Interactive Discussion: Author Response to Editor

Variability and persistence of scour at bridges using stochastic simulations

Alonso Pizarro, Oscar Link, and Demetris Koutsoyiannis
NHESS Discussions, doi: 10.5194/egusphere-2025-6530

Interactive Discussion: Author Response to Reviewer 01

Figure 1: Analysed catchment (Fig. 1a) and streamflow data visualisation (Fig. 1b) of two hydrological years (2008 and 2009). Notice that the hydrological year starts on the 1st of April."

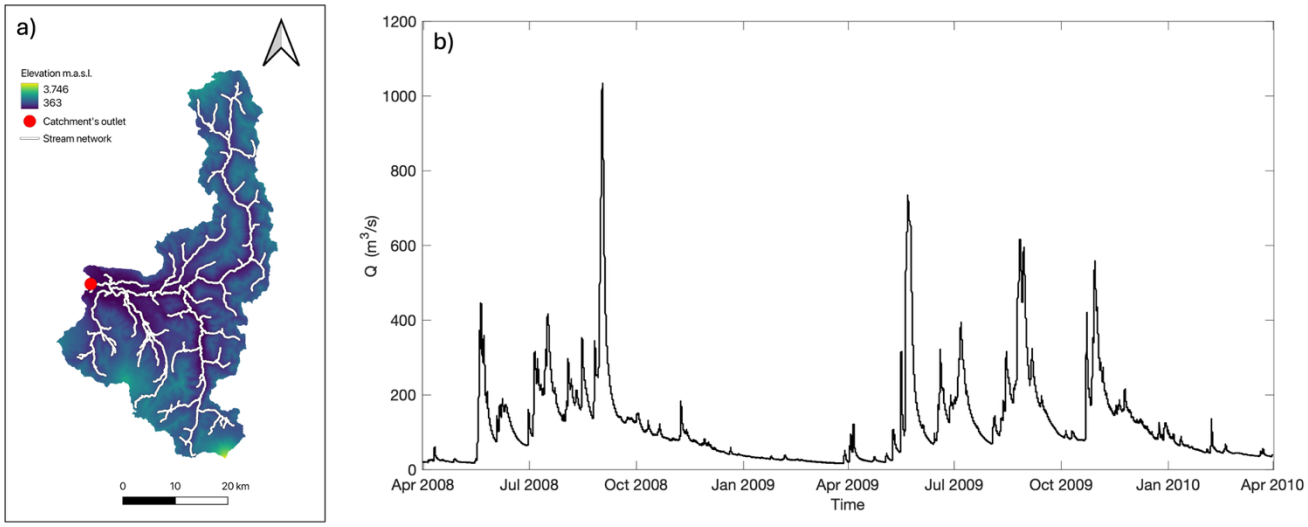
RC 8: Fig 1: a) Shape outlines make the bottom part of Chile appear black. b) There are some weird stream segments which are unconnected or even seem to cross the catchment border. Legend missing.

AR 8: The figure in question was improved:
